# UNITED STATES PATENT AND TRADEMARK OFFICE

APPLICATION NO.	FILING DATE	FIRST NAMED INVENTOR	ATTORNEY DOCKET NO.	CONFIRMATION NO.
09/834,350	04/13/2001	George Adaniya	61650- 011 (ALPL-110)	2426

# Office Action Summary

## DETAILED ACTION

FIG. 1

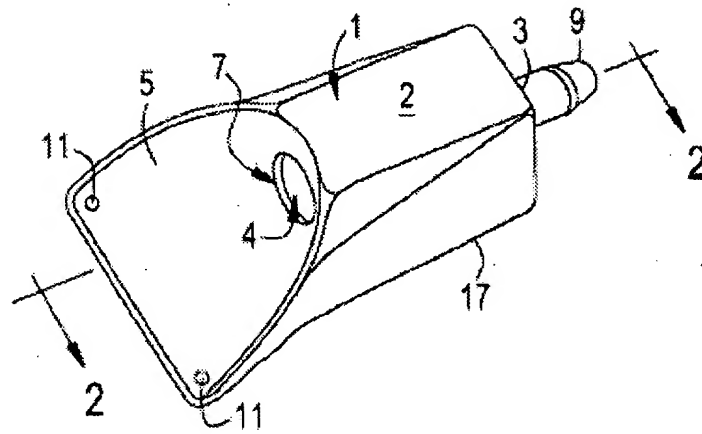
Villani discloses an implantable access device having a plate(s), at least two walls in the broadest interpretation. See figs. 1-9. The walls being any of the 4 walls (on either side of 37 are at least 2 walls depending on the interpretation). The valve assembly is considered to be the septum which is capable of performing the function as claimed. It is normally closed until it has been pierced by a filament. The shape of the plate and the distance between the walls are decreasing monotonically.
